## Response to the Reviewers' Comments

The authors would like to thank the reviewers for the precious comments and suggestions on the technical contents and presentation of our manuscript "Runtime Power Management of Battery Electric Vehicles for Extended Range with Consideration of Driving Time," submitted to IEEE Transactions on Very Large Scale Integration (TVLSI.) This revised manuscript has been greatly improved thanks to the reviewers' invaluable advices. We have revised the manuscript faithfully following the reviewers's comments. We include the newly added or significantly modified parts in the revised version of the paper also in Response to Reviewers. We highlight the important technical content changes and set those parts in a red color in the revised paper.

Fig. 2: (a) Range-speed experimental data for Chevrolet Bolt [36] and (b) comparison with simulation results of the proposed EV power model.

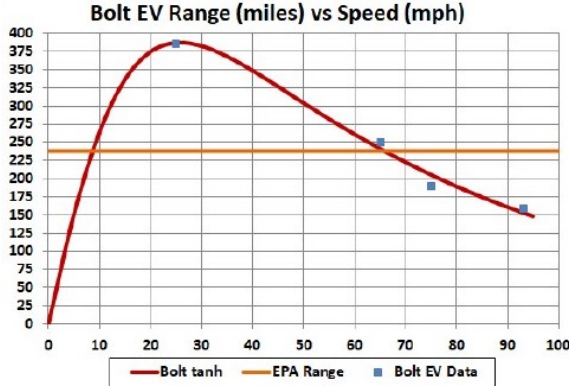
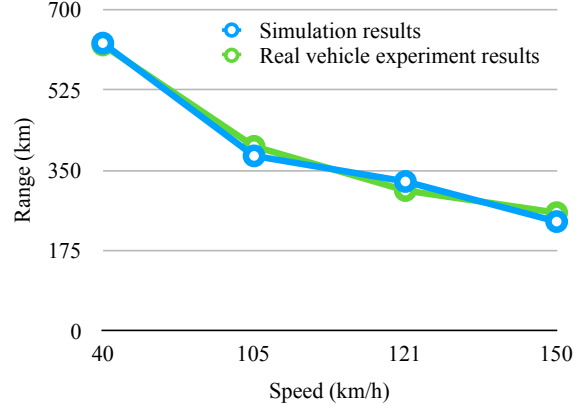
**R1-C2** It is not clear how to validate the power model of EV. As the author mentions that accuracy of power model is quite important, it is good to see the power model in this paper can be validated by some real measurement results.

We further evaluate the model accuracy with the range-speed real vehicle experiments as shown in Fig. 2(a) to confirm the derived power models are close enough to the real vehicle measurement data [32], [33], [34], [35], [36]. We refine the coefficients until all the available data values match well.

As a result, the derived EV power model well matches with the range-speed experimental data as shown in Fig. 2(b) as well as the top speed and maximum acceleration setting the aerodynamic resistance, rolling resistance, curb weight, etc. with the known values. The errors in the range-speed simulation is merely 1.4%, the time for 0-to-100 km/h error is 7.8%, and the top speed error is 3.0%, respectively. We revised the manuscript adding the following paragraph with a new figure in Section III.A on page 3 and 4.

We further evaluate the model accuracy with the range-speed real vehicle experiments as shown in Fig. 2(a) to confirm the derived power models are close enough to the real vehicle measurement data [32], [33], [34], [35], [36]. We refine the coefficients until all the available data values match well.

As a result, the derived EV power model well matches with the range-speed experimental data as shown in Fig. 2(b) as well as the top speed and maximum acceleration setting the aerodynamic resistance, rolling resistance, curb weight, etc. with the known values. The errors in the range-speed simulation is merely 1.4%, the time for 0-to-100 km/h error is 7.8%, and the top speed error is 3.0%, respectively.

Fig. 12: Velocity profile comparison with  $EDP$ ,  $E^2DP$  and  $E^3DP$  on Serrano Avenue in Anaheim Hills.

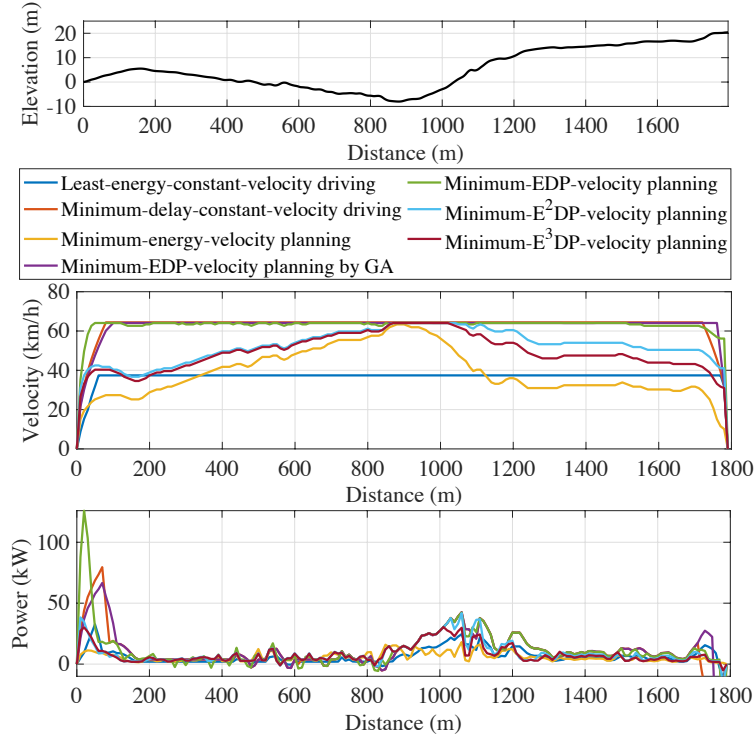
**R1-C3** The optimality of the proposed scheduling algorithm is unclear. The author should add several paragraphs to discuss this topic. It is also to see the comparison baseline is well accepted to show the advantage of the proposed algorithm.

Fig. 13 summarizes  $EDP$  of the least-energy-constant-velocity driving, the minimum-delay-constant-velocity driving, the minimum-energy-velocity planning, the velocity planning with  $EDP$ ,  $E^2DP$  and  $E^3DP$  as a metric on the road benchmarks and the minimum-EDP-velocity planning with GA. The proposed velocity planning results in up to 46.2% improvements of  $EDP$  compared with the least-energy-constant-velocity driving. The driving velocity on a flat road is faster than that of the least-energy-constant-velocity driving at the expense of relatively little energy to save driving time. Then, the velocity decreases when climbing the following uphill to spend less motor torque, which saves more energy.

We also updated Fig. 12 and Fig. 13:

Fig. 11: Histograms of velocity and acceleration for the proposed energy-aware-velocity planning methods without an acceleration constraint (a) and (b) and with an acceleration constraint (c) and (d), respectively.

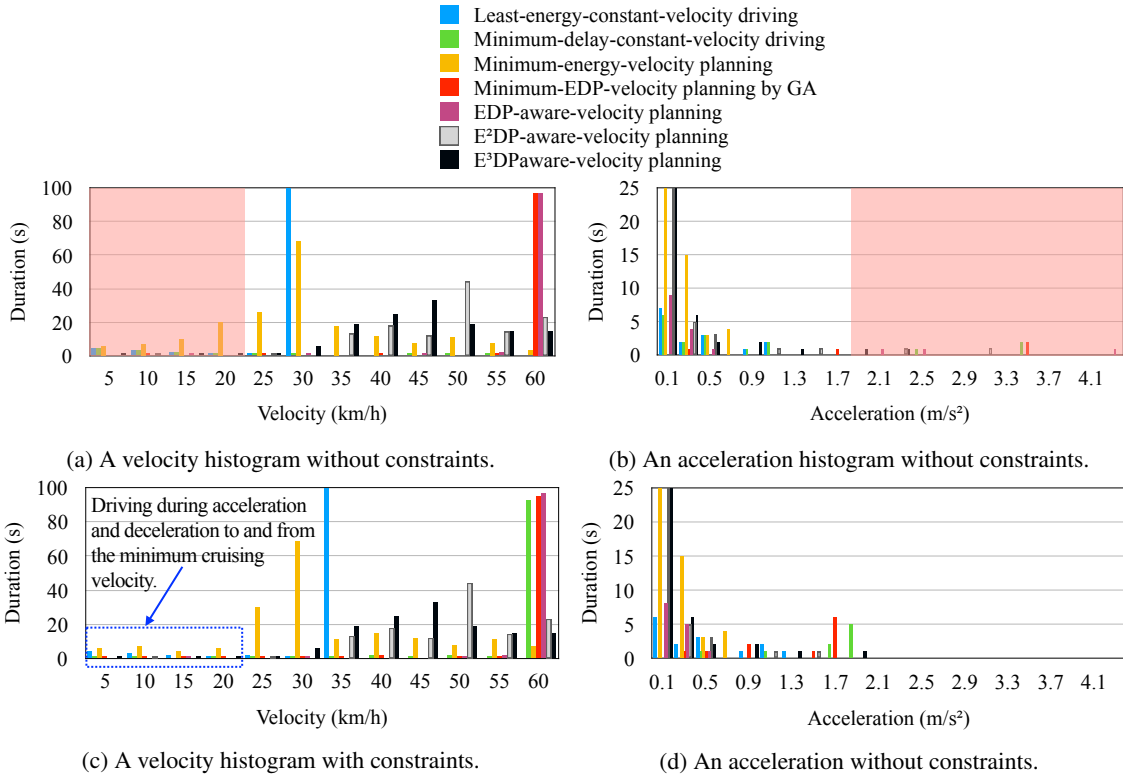
**R2-C2** It would be good to have more discussion on the assumptions of the approach and the experiments, e.g., how much can the velocity be changed in practical scenarios without impeding traffic and causing unsafe situations (also depending on the road conditions and whether it is urban or rural environment I suppose). Currently, there only seems to be one constraint on not slower than 10 km/h.

We quantize the velocity and acceleration values and make a histogram to analyze population of velocity and acceleration for the proposed energy-aware-velocity planning methods. Fig. 11(a) and (b) show two histograms of the driving schemes in Fig. 12, which do not have velocity and acceleration constraints. We avoid a cruising velocity lower than 25 km/h and an acceleration higher than  $2.0 \text{ m/s}^2$  in this paper without loss of generality. The acceleration of  $2.0 \text{ m/s}^2$  is the same as the maximum acceleration of compact cars designed to be used primarily used in urban areas (13 seconds of 0-to-100 km/h time).

Fig. 11(c) and (d) shows the velocity and acceleration histograms with the constraints. Once we run the DP for the first time without constraints, we analyze the histogram, adaptively determine the minimum cruising velocity and maximum acceleration constraints, and run DP again. We keep the same constraints for online recomputation whenever unexpected interrupts occurs.

We quantize the velocity and acceleration values and make a histogram to analyze population of velocity and acceleration for the proposed energy-aware-velocity planning methods. Fig. 11(a) and (b) show two histograms of the driving schemes in Fig. 12, which do not have velocity and acceleration constraints. We avoid a cruising

velocity lower than 25 km/h and an acceleration higher than  $2.0 \text{ m/s}^2$  in this paper without loss of generality. The acceleration of  $2.0 \text{ m/s}^2$  is the same as the maximum acceleration of compact cars designed to be used primarily used in urban areas (13 seconds of 0-to-100 km/h time).

Fig. 11(c) and (d) shows the velocity and acceleration histograms with the constraints. Once we run the DP for the first time without constraints, we analyze the histogram, adaptively determine the minimum cruising velocity and maximum acceleration constraints, and run DP again. We keep the same constraints for online recomputation whenever unexpected interrupts occurs.

Fig. 8: Altitude changes in the real road benchmarks.

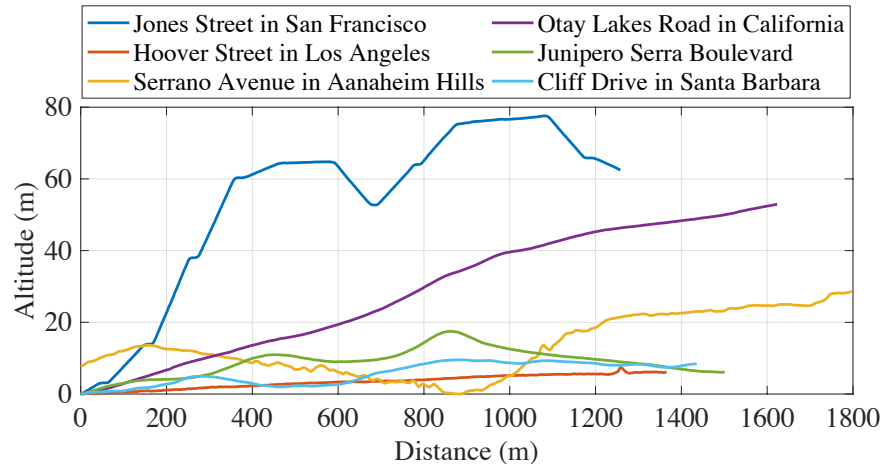
**R2-C3** Related to the last point, it would be good to have more discussion on the road benchmarks, e.g., how they are generated and how representative they are. The optimization results significantly depend on road slope. It would be good to use a variety of real road segments for testing.

**R2-A3** We appreciate the reviewer's comment. We replaced the previous synthetic road benchmarks with the real road benchmarks. We made six new real road benchmarks from various locations in California. The first three roads are in cities. Jones Street in San Francisco and Hoover Street in Los Angeles are two representative city landscapes such as hills and flat roads, respectively, and Cliff Drive in Santa Barbara is a mixture of those. The second two roads are in mountain areas: Serrano Avenue in Anaheim Hills and Otay Lakes Road in San Ysidro Mountain in California. The last road is Junipero Serra Boulevard connecting San Francisco and San Jose. The details of road data is summarized in Table II, and Fig. 8, which visualize the altitudes of the road benchmarks. We also revised all the associated contents with the new real road benchmarks.

We choose six roads from various locations in California and make real road benchmarks. The first three roads are in cities. Jones Street in San Francisco and Hoover Street in Los Angeles are two representative city landscapes such as hills and flat roads, respectively, and Cliff Drive in Santa Barbara is a mixture of those. The second two roads are in mountain areas: Serrano Avenue in Anaheim Hills and Otay Lakes Road in San Ysidro Mountain in California. The last road is Junipero Serra Boulevard connecting San Francisco and San Jose. The details of road data is summarized in Table II, and Fig. 8, which visualize the altitudes of the road benchmarks.
